MHTN
ARCHITECTS

Addendum No. 02

Project Name: **SJSD Albert R. Lyman Middle School**

Addendum No. 02 to the Construction Contract for the above-referenced project:

STAIR AND RAMP SECTIONS

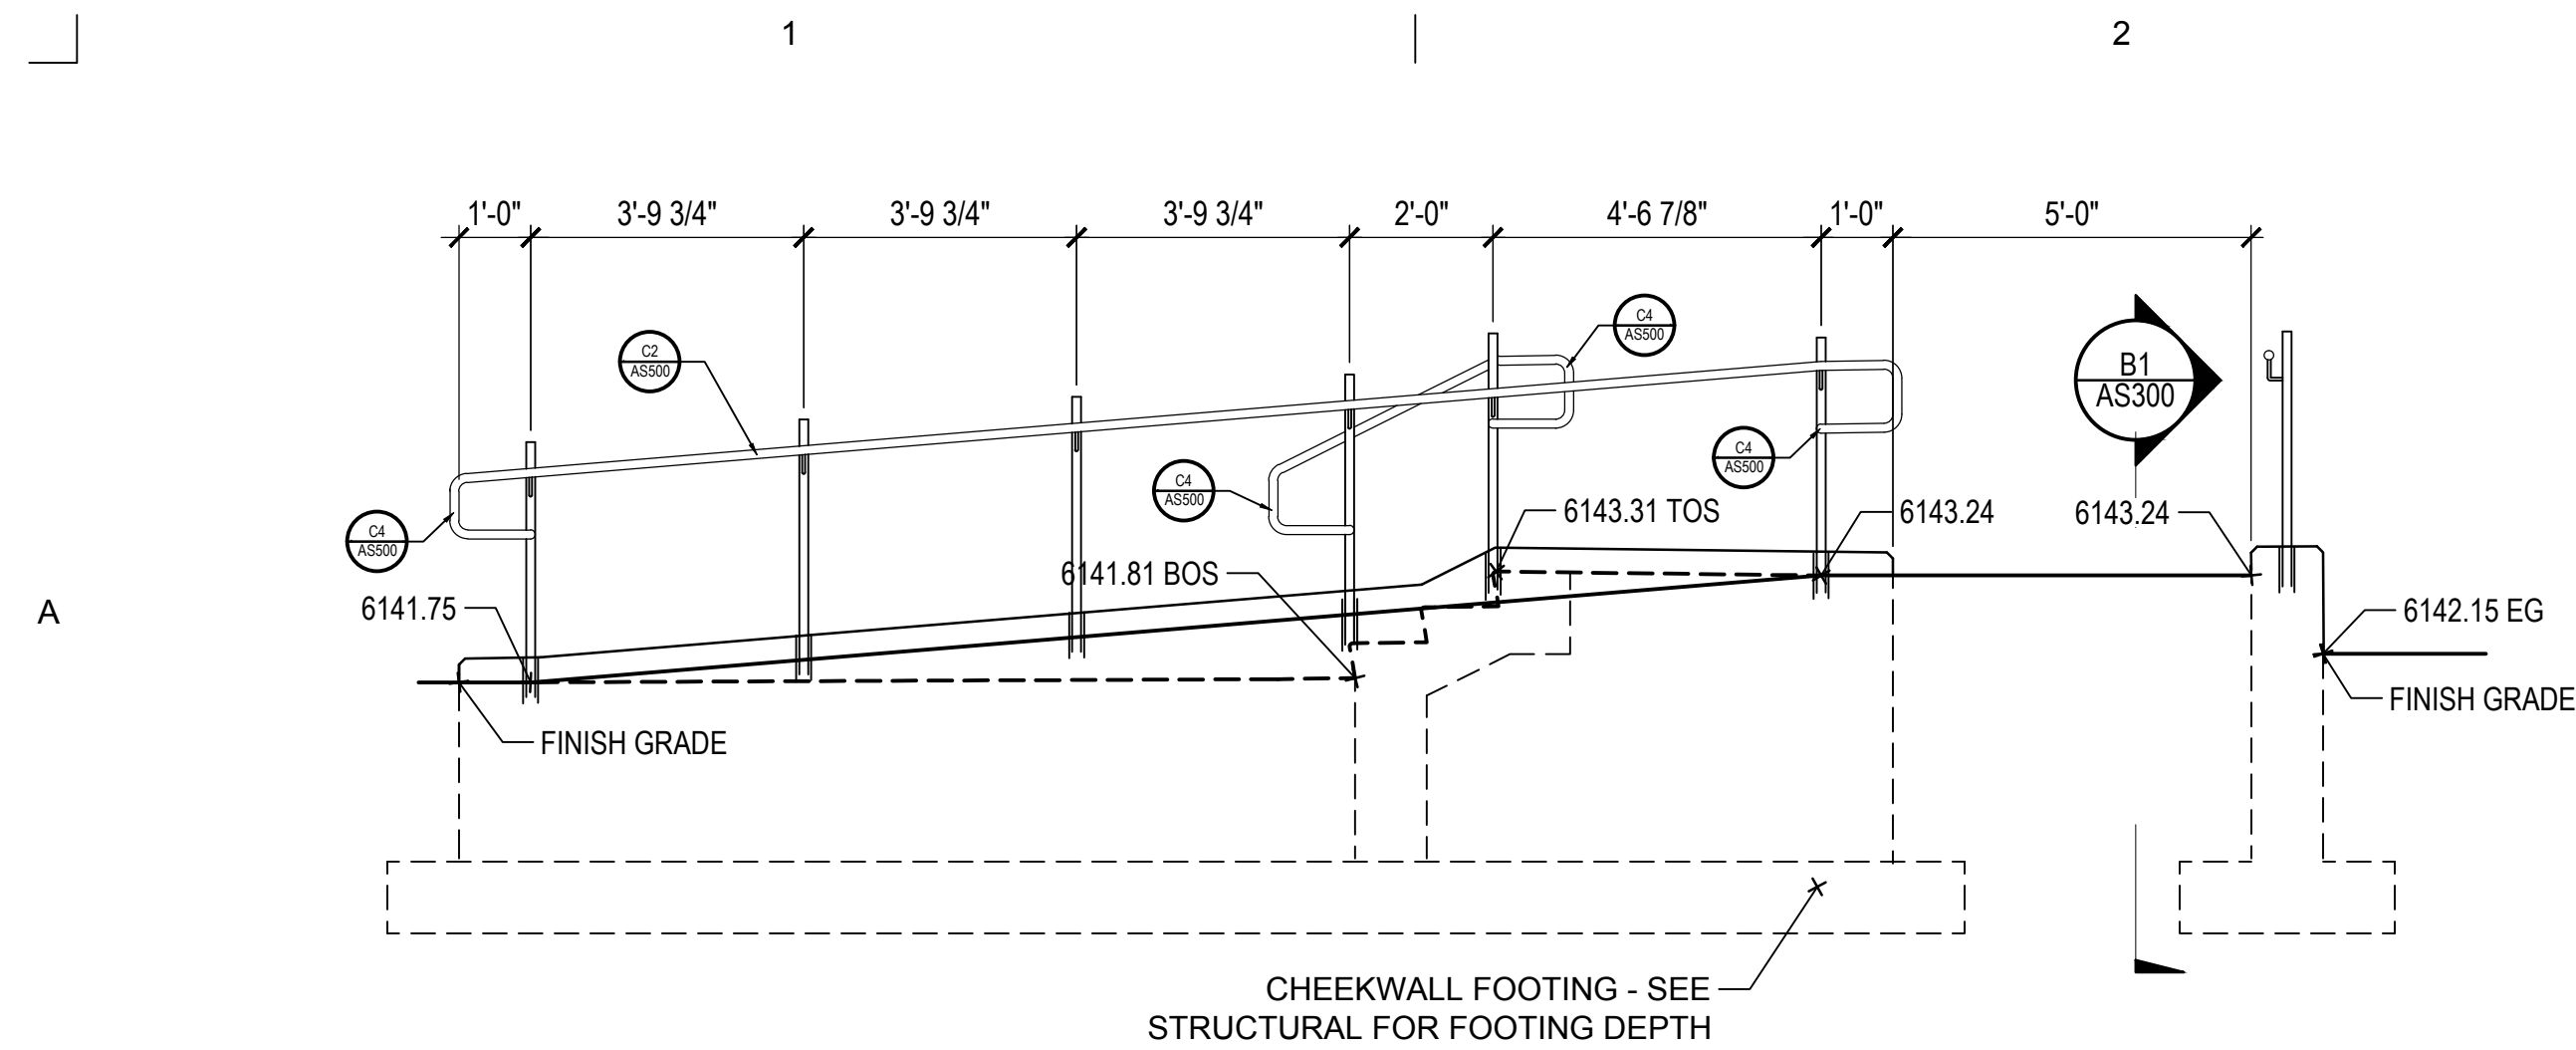
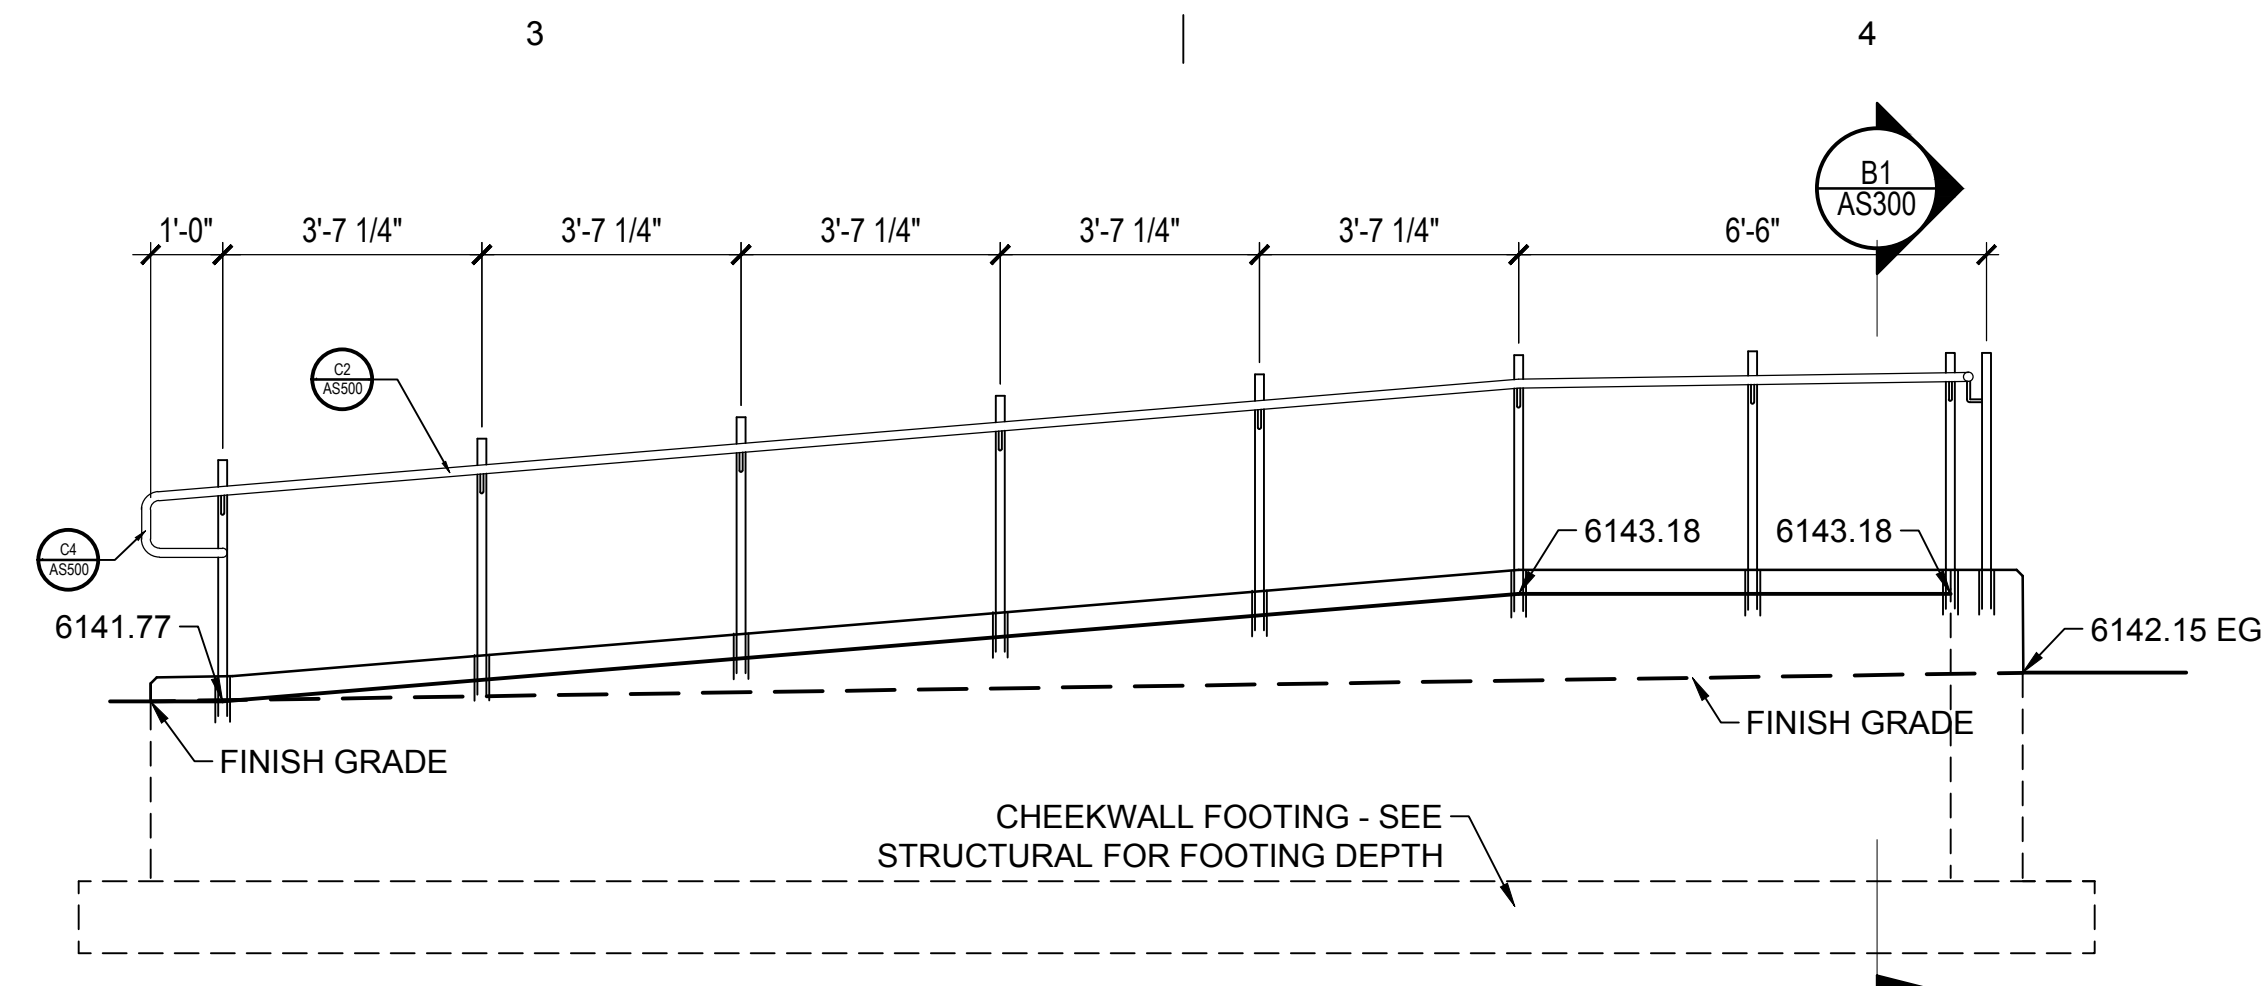
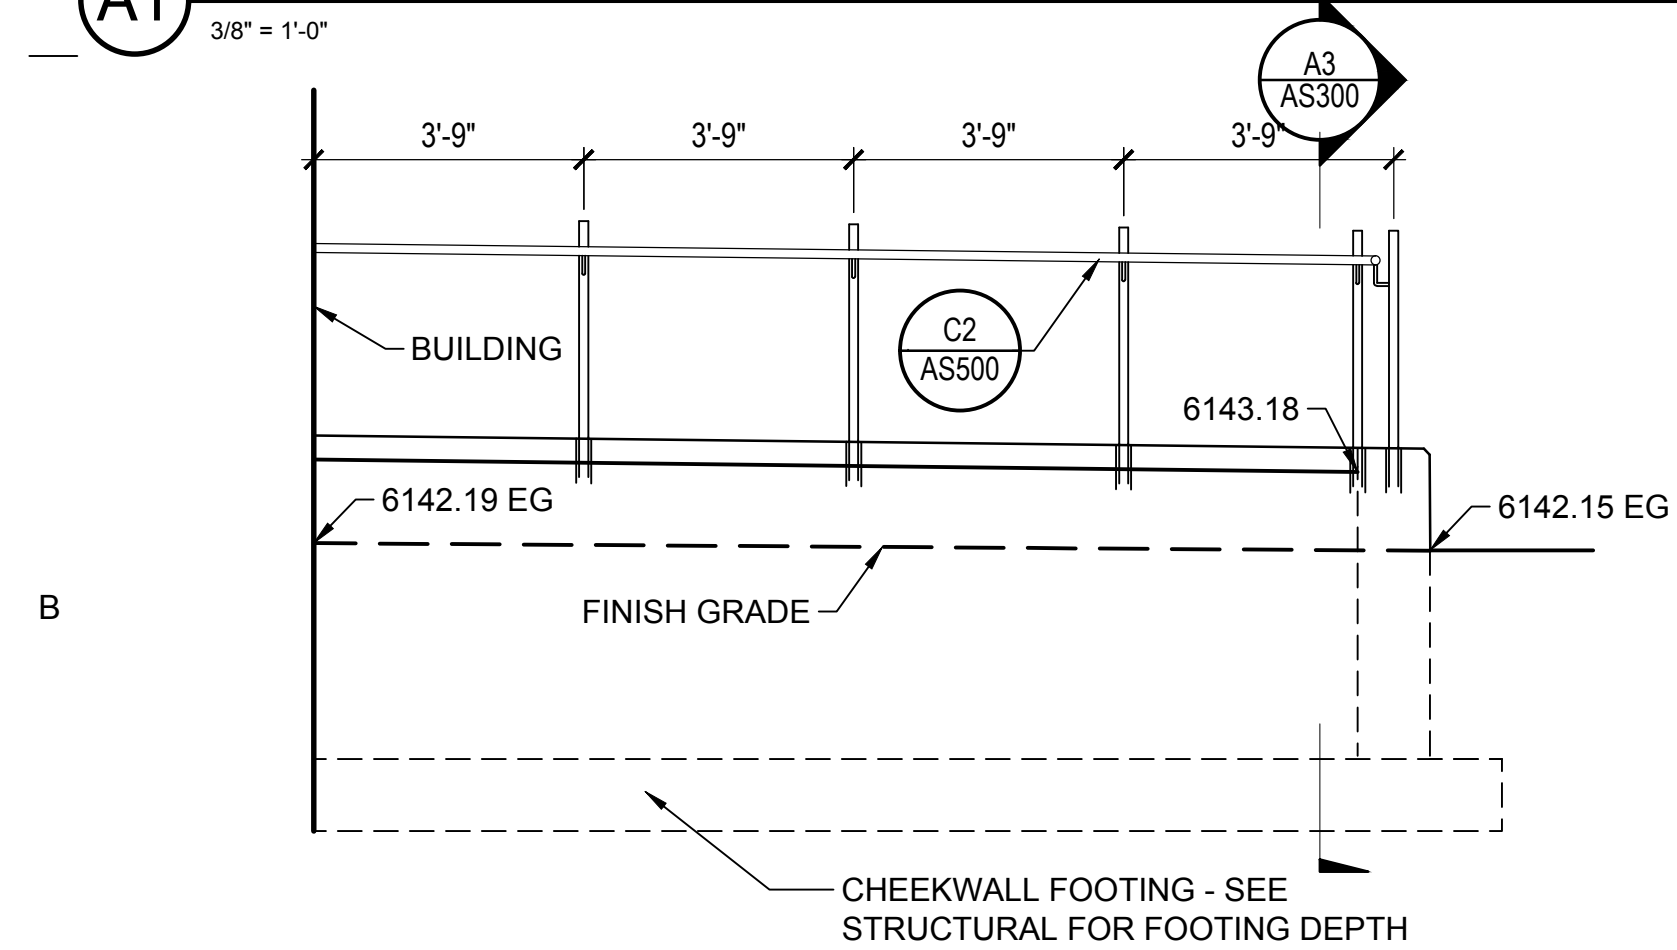
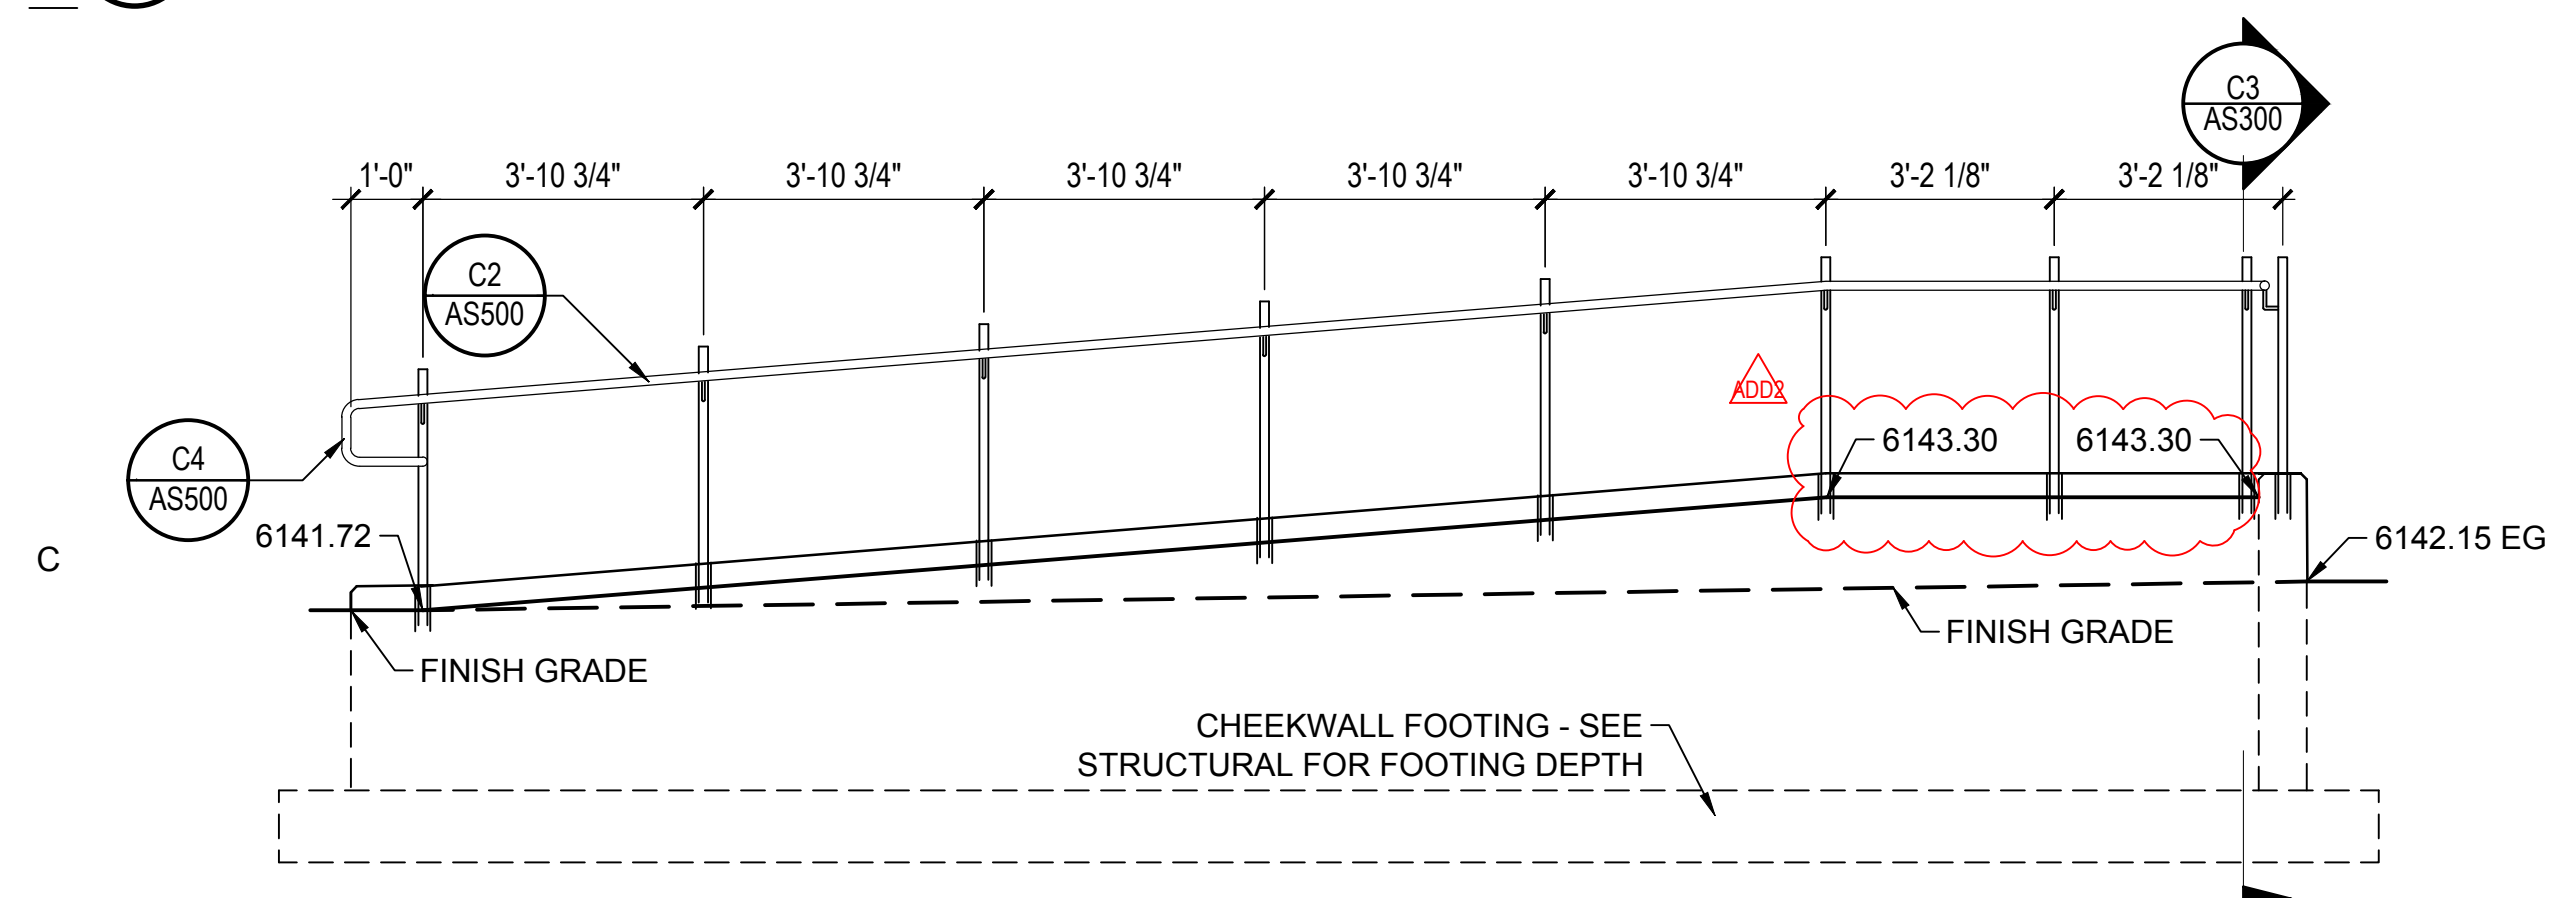
1. Added elevations and details to clarify cheekwall locations and construction.
